PA TECHNICAL BULLETIN

Technical Bulletin No. : TB-PA-2006001

MODEL: DT-300, DT-900, DT-X5, DT-X10 and IT-3000

SUBJECT: Notices on software related to the new RoHS-compliant models

Fig 1 Example of Copy Device Menu

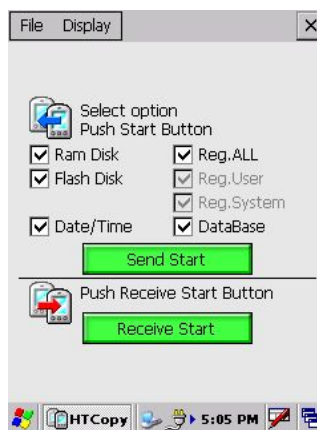
3. Under this condition, execute the “Copy Devices” on the master terminal and then on each target terminals.
- If the master terminal has older patches than the target, the patches on the target terminals will be downgraded after executing the Copy Device. Moreover, the target terminals will have two kind software by the old and new patch files and may cause troubles due to the inconsistency. Service Pack 1.00 for the IT-3000 CMOS models and CMOS Patch 1.00 will be released to support the new CMOS imager modules. When the SP or the Patch is installed, in other words, the CAB file is extracted, new CMOS controller will be installed automatically by judging the kind of CMOS imager module. Therefore, the software which is installed in the Windows folder on RAM is different according to the integrated CMOS imager module and you need to copy Service Pack or Patch into FlashDisk and then execute the Copy Device. You need to set the Copy Device to send files not only in RAM but also in FlashDisk.

Be sure to check on Flash Disk and copy SP or Patch into Flash Disk.
